Mask Set Errata for Mask 0M75B

This mask set errata applies to the mask 0M75B for these products:

- MC9S08AW60
 - MC9S08AW48
 - MC9S08AW32
 - MC9S08AW16
-

**Case 1****Case 2****Figure 1. HCS08 SIM Reset Lockup**

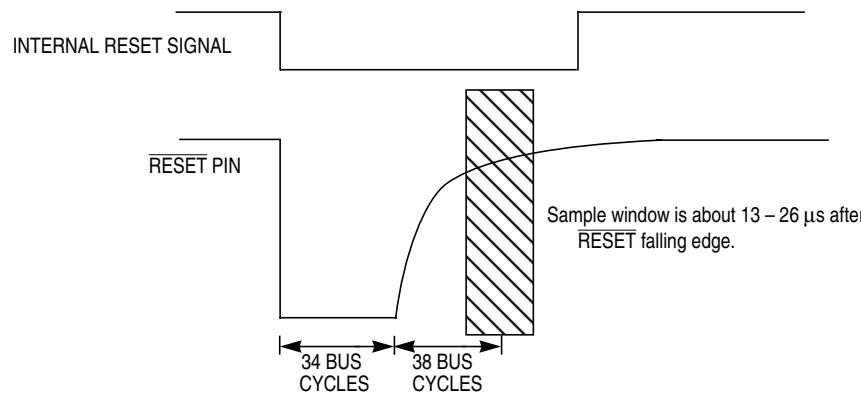
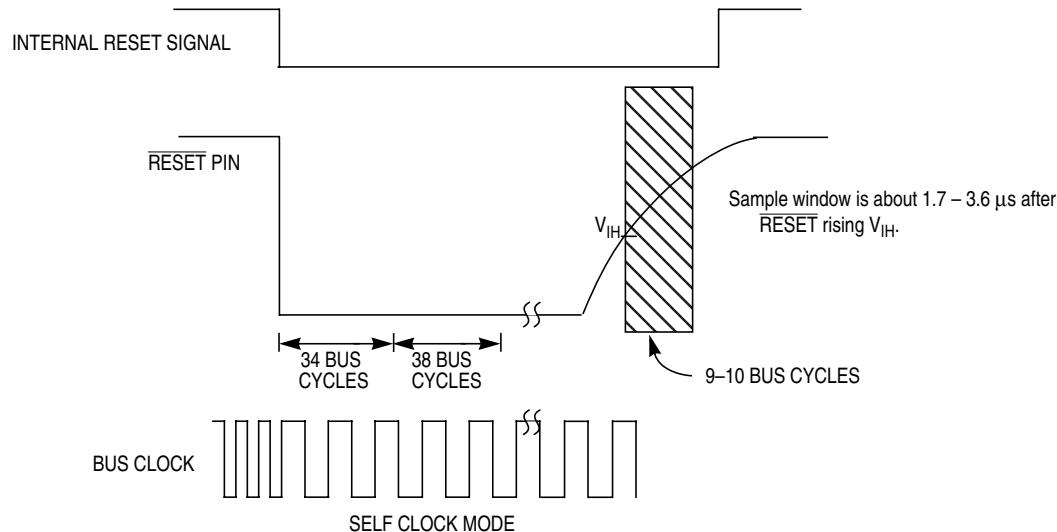
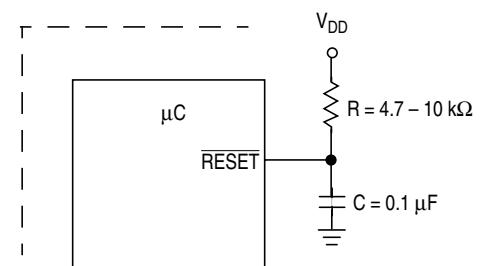
If a falling edge is detected on the external reset pin at either of two sample points, the MCU will cease operation and will recover only after a power-on reset.

Case 1 — After detecting a reset signal, either internal or external, the internal reset circuit latches the cause of the reset, forces a low level on the external RESET pin for about 34 bus cycles, releases the pin, and samples the pin level about 38 bus cycles later. The ICG will revert to self-clock mode (SCM) at the beginning of the reset cycle. Therefore, the first sample window is about 13 μ s to 26 μ s after the initial reset signal, due to the frequency range and characteristics of the internal oscillator.

Case 2 — After remaining in reset for an extended period of time due to an externally applied low level on RESET, the internal reset circuit will sample the pin level about 9 to 10 bus cycles after the pin raises above its V_{IH} level. The ICG will revert to self-clock mode (SCM) during reset. Therefore, the second sample window is about 1.7 μ s to 3.6 μ s after the reset signal rises above V_{IH} , due to the frequency range and characteristics of the internal oscillator.

To avoid multiple edges on the RESET pin due to switch contact ringing or EMC noise, eliminate any voltage bounce through RC filtering. A 0.1 μ F capacitor to ground and an external 4.7 k Ω to 10 k Ω resistor to V_{DD} works well to ensure noise suppression.

In addition to RC filtering, avoid spurious edges on the $\overline{\text{RESET}}$ pin caused by external active circuitry such as low voltage detectors and watchdog components. Do this by ensuring that external circuitry cannot drive $\overline{\text{RESET}}$ low within 10 bus cycles of the release of $\overline{\text{RESET}}$.
